The Peelle Company Limited

TECHNICAL BULLETIN

SUBJECT: INTERPOSING RELAY FOR LIGHT CURTAIN RECEIVER.

EQUIPMENT: PEELLE CAR DOOR LIGHT CURTAIN REVERSING DEVICE (PEELLE PART NUMBERS 4690 AND 4691) WITH OR WITHOUT PNP ADAPTER (46903).

EXISTING WIRING

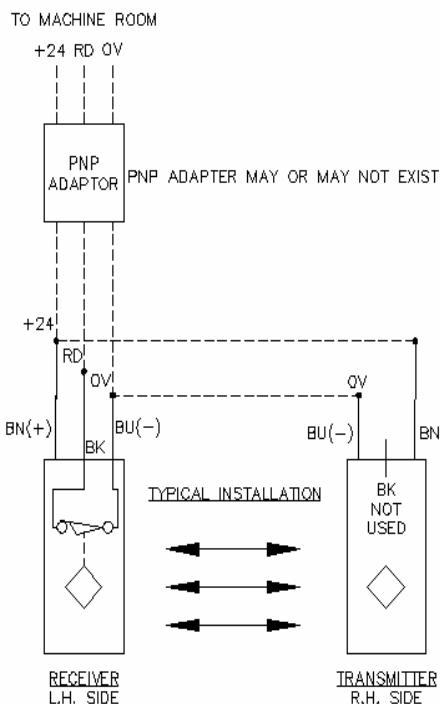
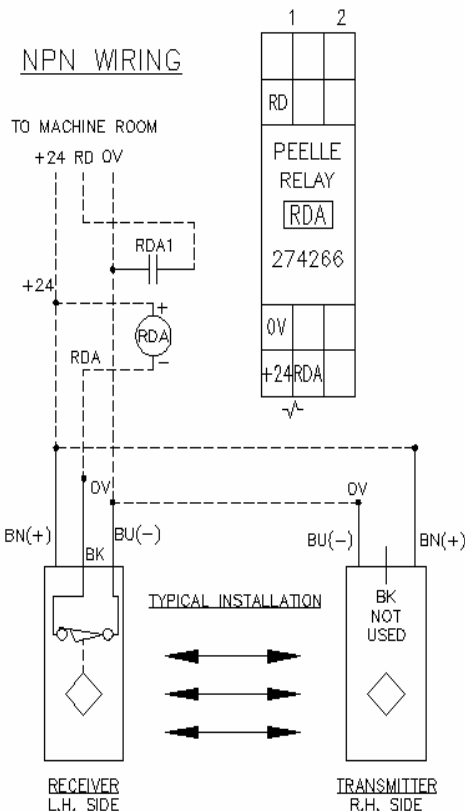
DESCRIPTION: THE LIGHT CURTAIN OUTPUT CIRCUIT OF THE RECEIVER MAY BE DAMAGED BY INDUCED VOLTAGE ALONG THE TRAVELING CABLE. AN INTERPOSING RELAY SHOULD BE INSTALLED ON TOP OF THE CAR TO SEPARATE THE LIGHT CURTAIN RECEIVER RD SIGNAL FROM THE MACHINE ROOM DOOR CONTROLLER.

- IF EXISTING WIRING HAS PNP ADAPTER (46903) FROM LIGHT CURTAIN RECEIVER, REMOVE AND DISCARD ADAPTER. WIRE INTERPOSING RELAY ACCORDING TO PNP CONNECTION DIAGRAM.
- IF EXISTING WIRING DOES NOT HAVE PNP ADAPTER, WIRE INTERPOSING RELAY ACCORDING TO NPN CONNECTION DIAGRAM.

NOTE: LIGHT CURTAIN WIRES- BROWN TO +24, BLUE TO 0V AND BLACK TO RDA.
